Subject: AP1000 Response to Request for Additional Information (SRP 3)

RAI-SRP3.8.4-SEB-02

Response to Request for Additional Information on SRP Section 3.8.4

RAI Response Number: RAI-SRP3.8.4-SEB1-02
Revision: 0

Fig. RAI-SRP3.8.4-SEB1-02-3 Shear-Friction Mechanism

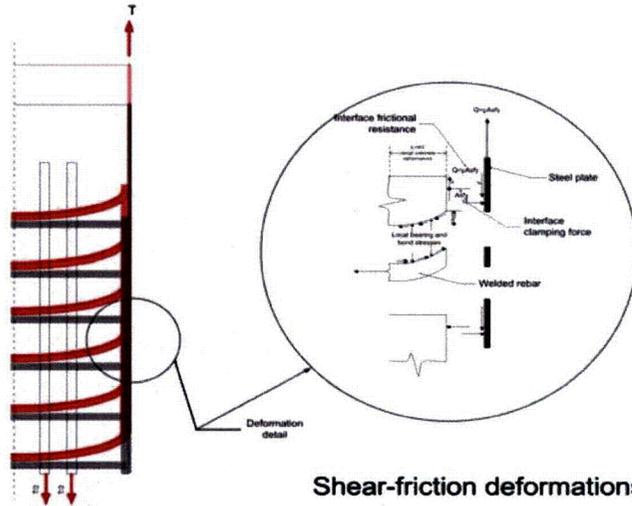
3. Provide a description of the basis for the design of the connections between the original SB reinforced concrete wall and the wall modules, the wall and the basemat, and the modules and the roof.

The dowels shown in Fig. RAI-SRP3.8.4-SEB1-02-2 are located in two vertical planes which are offset from the plane of the applied liner tensile force. The connection shown in Fig. RAI-SRP3.8.4-SEB1-02-2 is based on the shear-friction mechanism, as illustrated in Fig. RAI-SRP3.8.4-SEB1-02-3, and designed according to ACI provisions. It uses ties normal to the surface plate consisting of #6 rebars, welded to the steel face. The length of the bars is sufficient to develop the strength of the bar in accordance with the development length requirement of ACI 349.

Fig. RAI-SRP3.8.4-SEB1-02-4 Five Connection Locations

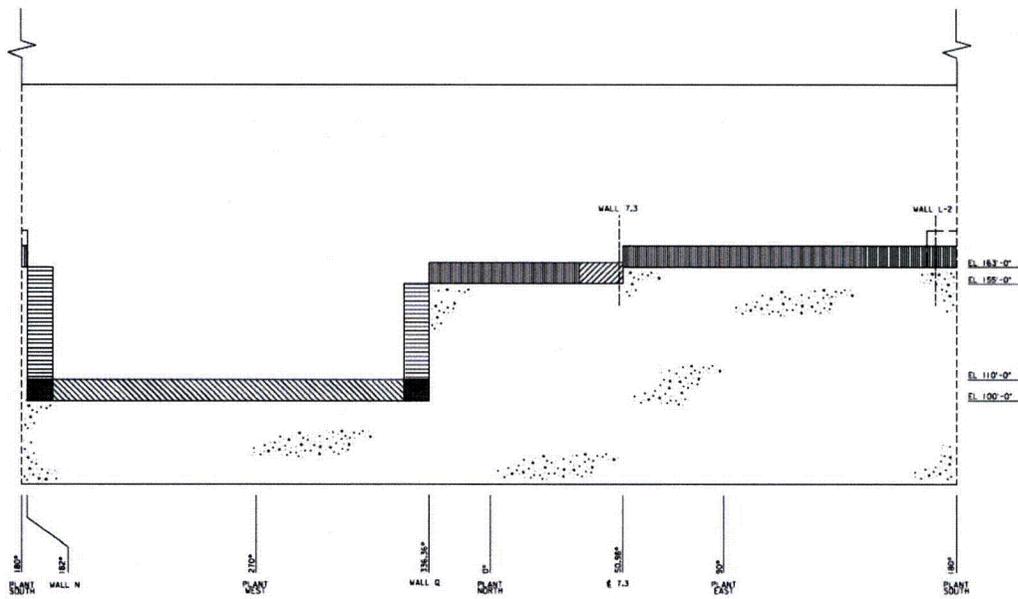
**C. With Regard to the Subject of:
Anchorage Design from SC Module Cylindrical Walls to the Basemat, and
Connection Design between SC wall Modules and Reinforced Concrete Walls**

The remaining SC module cylindrical walls are connected to the reinforced concrete cylindrical walls below. Since the heights of the reinforced concrete cylindrical walls are varied along the circumferential (hoop) direction, there are two types of connections, one in the meridional (vertical) direction and the other in the hoop direction, to be made. Neither was designed nor detailed in the DCD Revision 16. Therefore, the applicant is requested to provide the design detail of, and its design method for, the connections, and the test data that can substantiate the adequacy of the design method.

The SC modules are connected to RC along the interface, shown in Figure RAI-SRP3.8.4-SEB1-02-4, by a connection zone such as illustrated in Fig. RAI-SRP3.8.4-SEB1-02-2 for a typical section of the SC shield building wall above the RC basemat at El. 100'. The wall may be subjected to any combination of axial and shear forces and bending and torsional moments. These forces are resisted by the steel surface plate of the SC construction and by #11 rebar dowels rising from the basemat at El. 100', with the SC connection zone above serving a splicing function.

In addition to El. 100', four other connection locations are identified, as shown in RAI-SRP3.8.4-SEB1-02-4 in different hatch patterns:

- Corners at El. 100' between SC and adjacent RC walls
- Vertical planes at interface with adjacent RC walls
- Horizontal planes just above roof of auxiliary building at El. 155' and 163'
- Vertical plane between El. 155' and 163' above roof of auxiliary building

Connections at vertical interfaces connect circumferential reinforcement and are subjected to circumferential tensile forces and are similar to that described above for the horizontal interface. A typical corner connection is shown in Fig. RAI-SRP3.8.4-SEB1-02-5 and connects both vertical and horizontal reinforcement with the tie bars sized for a combination of both vertical and circumferential forces.

Fig. RAI-SRP3.8.4-SEB1-02-6 Typical CA Module

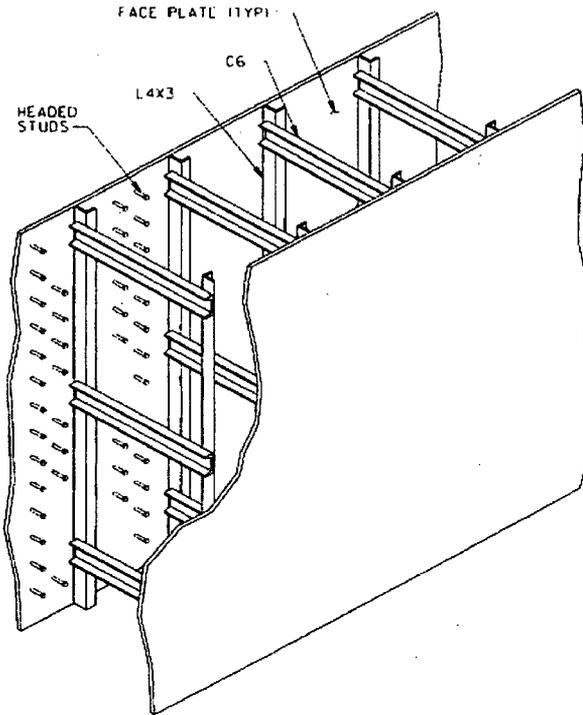
4. Provide a description of the SB construction sequence at the SB roof and other areas.
5. Address absence of thru wall trusses in modules and use of wire rope.

Typical CA Modules, illustrated in Fig. RAI-SRP3.8.4-SEB1-02-6, include C6 channels, welded to the vertical L4x3 angles. Their function is primarily to resist the wet concrete pressures during construction. As a result of the concern that the C6 channels may become secondary missiles during a postulated aircraft impact, they were removed from the SB cylinder SC modules and replaced by wire ropes. As shown in Fig. RAI-SRP3.8.4-SEB1-02-7, Shield Building (SB) cylinder modules are different than other CA modules due to the absence of through wall steel, except in local areas close to base, at air inlets, and at auxiliary building wall discontinuities.

Fig. RAI-SRP3.8.4-SEB1-02-9 Typical Test Results -Tests #6 and #7

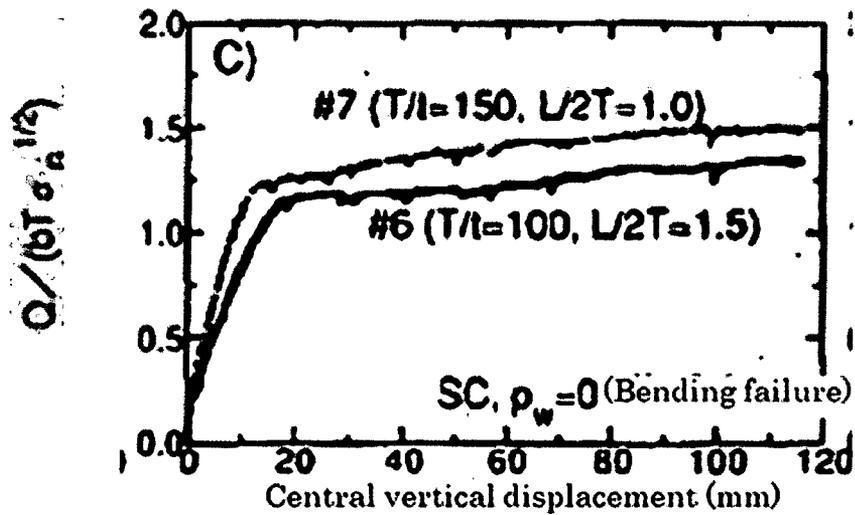
6. Address how curvature of cylinder wall is addressed in methodology and by testing if done.
7. Provide summary of test data directly related to behavior of shield building under loads.

Loading Pattern A, shown in Fig. RAI-SRP3.8.4-SEB1-02-9a, simulates distribution of member forces in specimens fixed at both ends. Fig. RAI-SRP3.8.4-SEB1-02-9b shows typical force versus mid-span displacements where $Q=2P$ (Kgf), b =specimen width (cm), T =specimen thickness (cm) and σ_B is the concrete compressive strength (Kgf/cm²)
